Air10[™] and Lumis[™] Product bulletin

Introducing a New Humidifier Tub to the Air10™ and Lumis™ for ANZ

Bulletin Number: PB#1183

Product Render of the Design of the New HumidAir™ Standard Tub

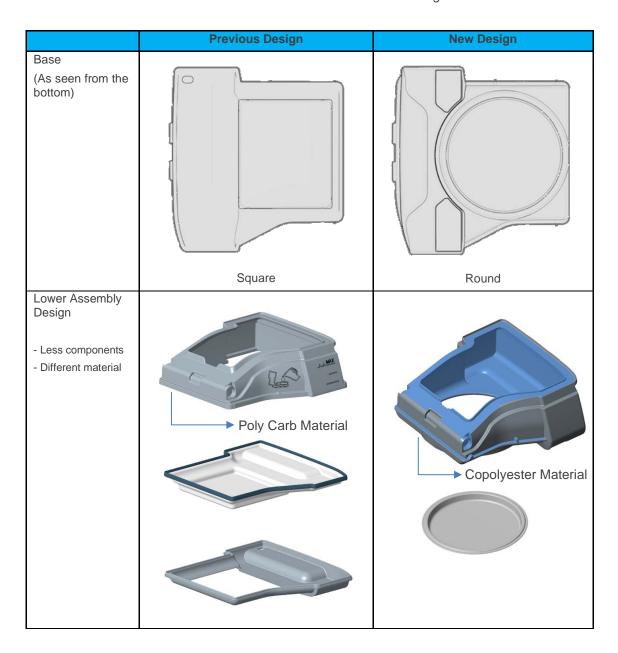
Introducing the latest improvement to the HumidAir™ Standard tub for the Air10™ and Lumis™ series of ResMed devices. Designed for single patient multi use, the new tub has a more efficient design and will be available as a spare part.

The new design has been introduced in ANZ from March 2024 for the spare product code. The spare part product code remains the same and the lot number breakpoint for the new design is below.

When inserted into a device, the new HumidAir™ Standard tub will have part of its metal plate showing (as seen in picture above). This is part of the intended design. Ridges along the side of the HumidAir™ tubs are designed to guide the user's hands for safe removal. The exposed metal plate is regulated to below touch temperature limits as specified by compliance standards and will not pose new safety issues to the user.

In the event of a fault, the heater plate will cut out once the temperature reaches 74°C (165°F).
